Informal document **GRE-79-04**
(79th GRE, 24-27 April 2018, agenda
item 7(a))

Task Force on Electro-Magnetic Compatibility (TF EMC)

Status report to GRE-79
Friday, 27. April 2018

TF EMC Status Report

(Change of the R10-05 narrow band limit consistent with CISPR 12)

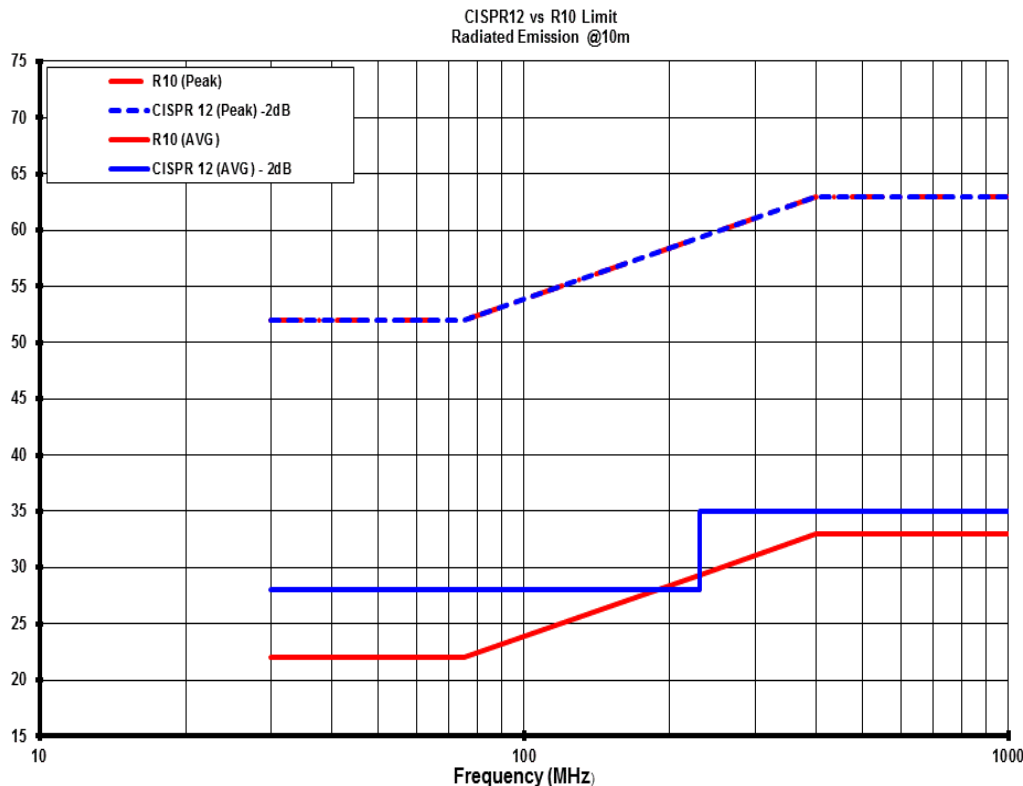
- It has been precised that in order to get a R10-05 vehicle narrowband emission limit consistent with the CISPR 12 vehicle narrowband limit, the **new R10.06 limit should** be the CISPR12-limit minus 2dB to take into consideration this 2dB more stringent requirement as defined in CISPR 12 for type approval.

For information:
This figure shows also the consistence between the R10-05 and CISPR12 broadband peak limits.

The proposal for new R10-06 narrowband limit is shown in blue, in comparison to the present R10-05 narrowband limit in red.
